**AROMA JOES**  
**SITE PLAN APPLICATION #08-21**  
**STAFF REPORT**  
July 28, 2021

**SITE:** 56 Derry Street; Map 173 Lot 029-000

Non-Residential Site Plan, Aroma Joe's; prepared by Keach-Nordstrom Associates, Inc., 10 Commerce Park North, Suite 3B, Bedford, NH 03110; prepared for owner: Steve S. & Hsiang Hwa W. Pan, 13 King Henry Drive, Londonderry, NH 03053 and owner/applicant: Scott Ziefelder, 169 Cannan Back Road, Barrington, NH 03825; consisting of 12 sheets plus a cover sheet, with general notes 1-29 on Sheet 2; dated June 22, 2021.

Re: Town of Hudson Planning Board Review  
Aroma Joe's Site Plan, 56 Derry Street  
Tax Map 173 Lot 29; Acct. #1350-970  
Reference No. 20030249.2040

**TP #1**

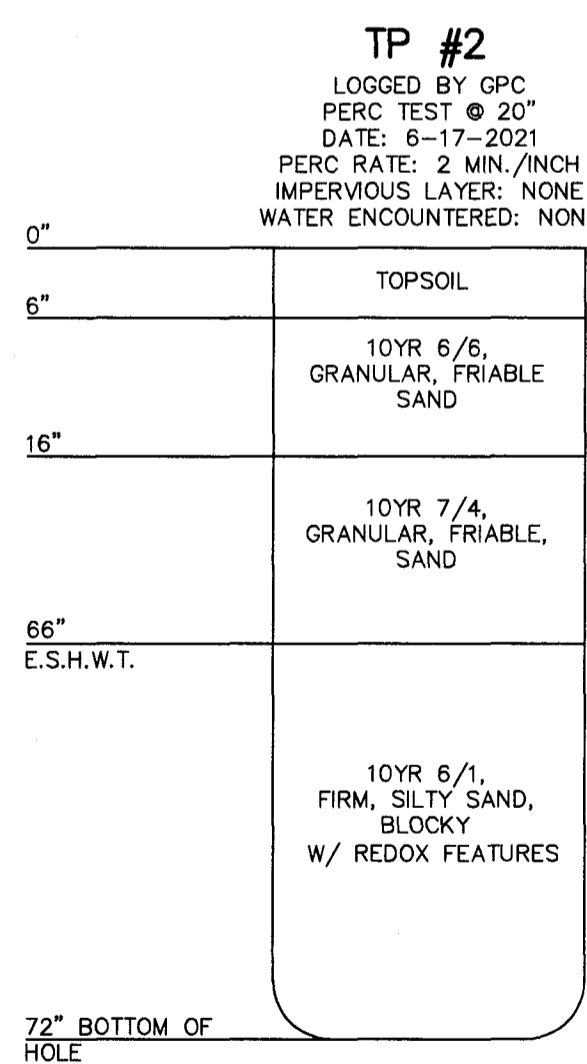
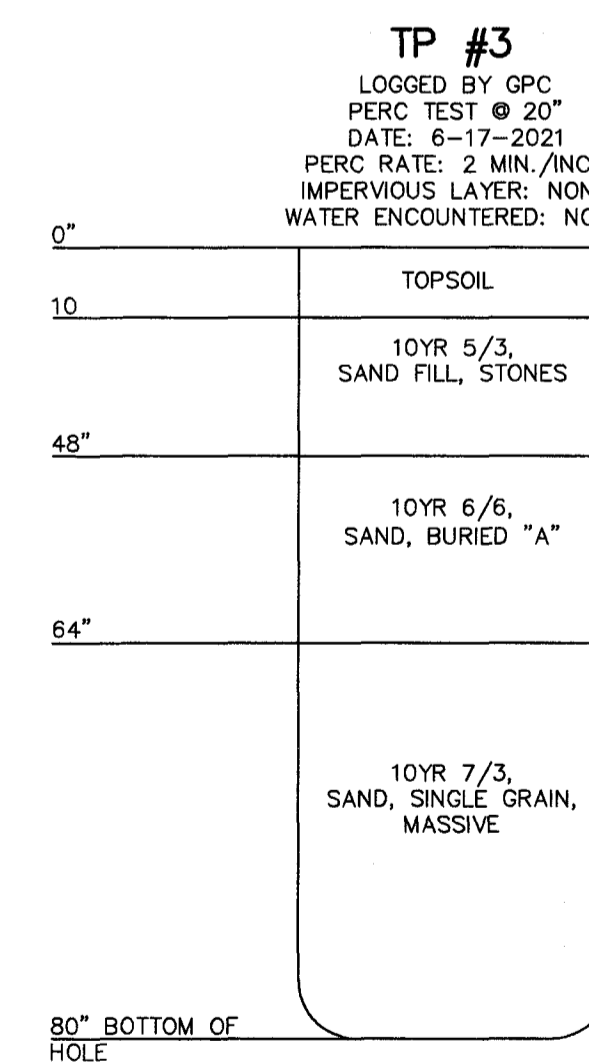
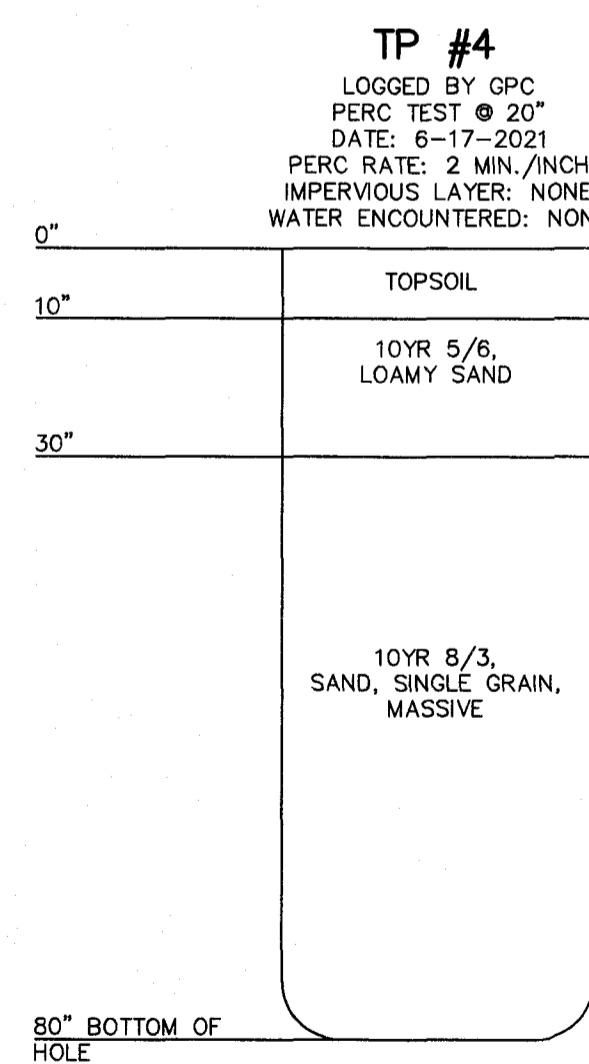
- a. HR 275-9.A.(3). The applicant should provide test pits within the footprint of the infiltration basin area, as required by NHDES and common engineering practice.

**SANITARY SEWER SERVICE DETAIL NOT TO SCALE**

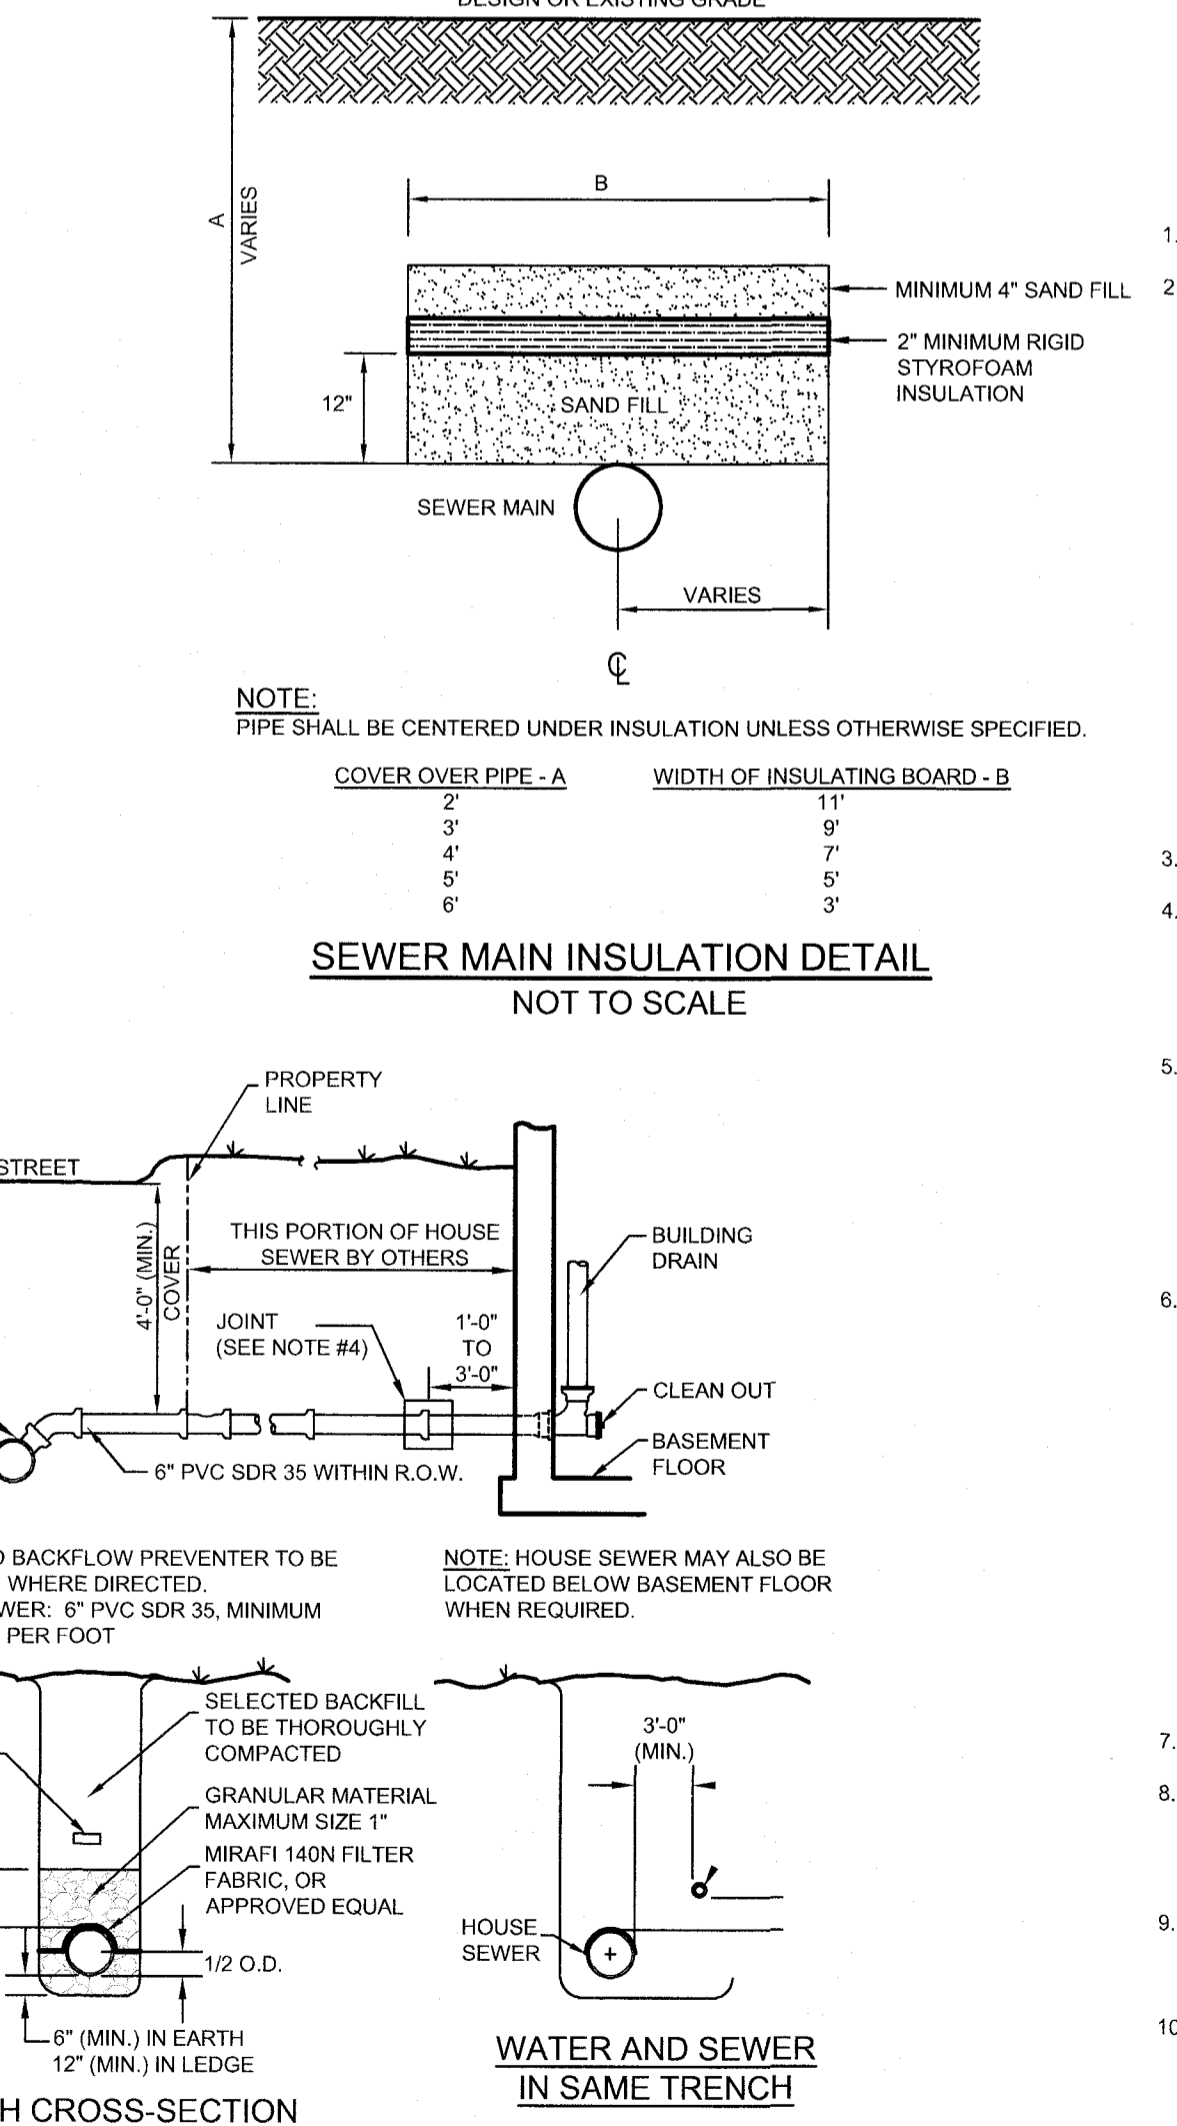
- a. Engineering Technical Guideline & Typical Details (ETGTD) Section 720.8.3. The applicant has not provided a cleanout for the proposed sewer service. This should be located at the property line.
- b. The applicant should provide a water/sewer crossing detail for the sewer service crossing the water main in Derry Street, and crossing details for the service piping at the drain line in the driveway.

1. Applicant shall add a sewer manhole, on their property by the property line, for future inspection or maintenance
2. The plan shows that runoff will sheet flow straight to the detention basins. It is not clear how a spill event will be handled without a catch basin equipped with a mechanical/oil separator.
3. Applicant shall add handicap ramp on both side of the entrance
